**DEVELOPMENT APPLICATION DA 2020/0816  
23-33 BASSETT STREET MONA VALE  
PROPOSED RESIDENTIAL CARE FACILITY UNDER SEPP HOUSING  
FOR SENIORS**

This document is a submission by way of objection to Development Application 2020/0816 (the 'development application') relation to Nos 23 - 33 Bassett Street Mona Vale (the 'subject property').

**Figure 1-** North elevation showing west boundary of site and relationship with adjoining cottage style development

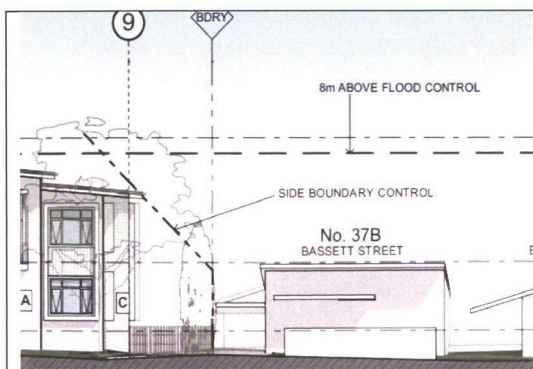
This site is not in a medium density residential zone nor is the property located in a mixed use commercial type environment. The fact that the site is zoned for 'low density residential' purposes should be instructive to the applicant as far as the development proposal is concerned. This is especially the case where low density residential extant development is to be replaced by a high density facility (over the eastern part of the land). We contend that the architect has failed to take into account the reasonable expectations of adjoining land owners and occupiers in this regard. Figures 1 and 2 below show the relationship between the proposal and adjoining development to the east and west (source Gartner Trovato Architects). In our opinion the separation between the built elements in Figure 1 is not acceptable.

In our view the building should be broken into at least two built elements crossways, so that some respect can be paid to the built form of existing cottages in other parts of this streetscape (with their narrow frontages), the relevant low density zone and the PDCP character statement suggesting that vegetation should be integrated with development. In this case the reduced street setbacks will not allow for sufficient planting to soften this bulky and very lengthy facade.

**Figure 4** – Extract from site plan showing proposed location of electricity kiosk

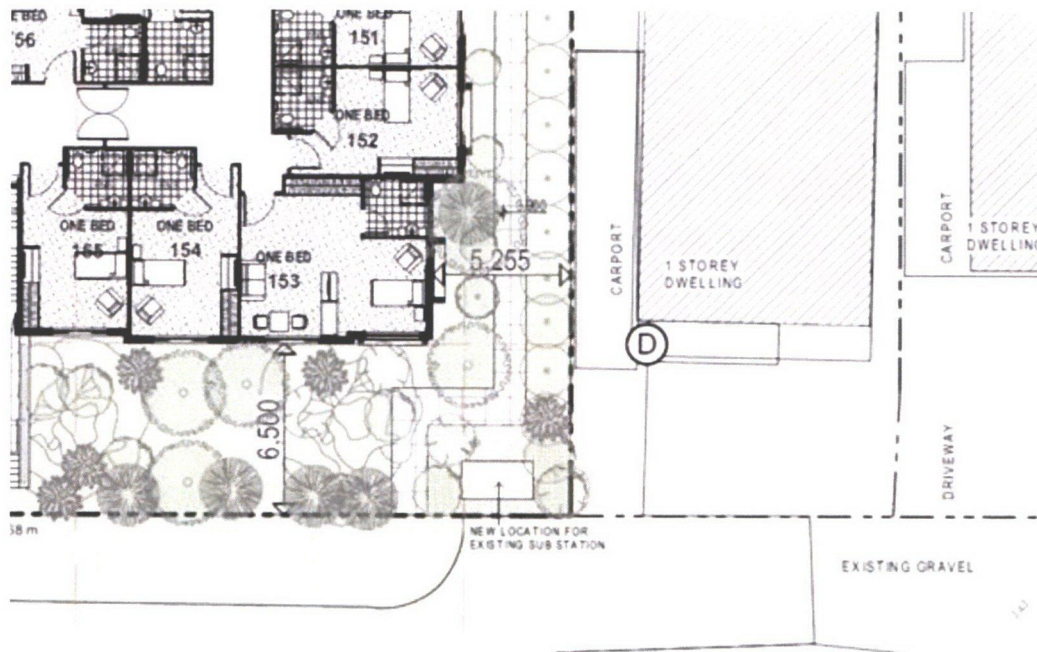
We object to the proposed location of the electricity kiosk due to potential adverse health impact impacts on both residents of the development and nearby neighbours.

Although details are not supplied in the application, the power generation capacity would need to increase given the increase electricity demand, thus transmitting increased levels of electrical and magnetic fields. While electric fields might well dissipate quickly with distance, the magnetic field which cannot be shielded from the existing sub-station (kiosk) is already in excess of prudent safety limits according to information supplied to us, by one of our clients.

As seen in the above image, the proposed new location for the existing substation is in close proximity, to the adjoining property to the west. The subject site, has an area of 6502sqm, and an alternative location for this substation, can easily be found, which will not provide any adverse EMF to the occupants and surrounding neighbours.

If Council is minded to grant consent to the development we request that Council impose a condition of consent to relocate the electricity kiosk, further along the street frontage to the east, perhaps 20m. The kiosk can be located in the front setback area with landscaped screening surrounding.
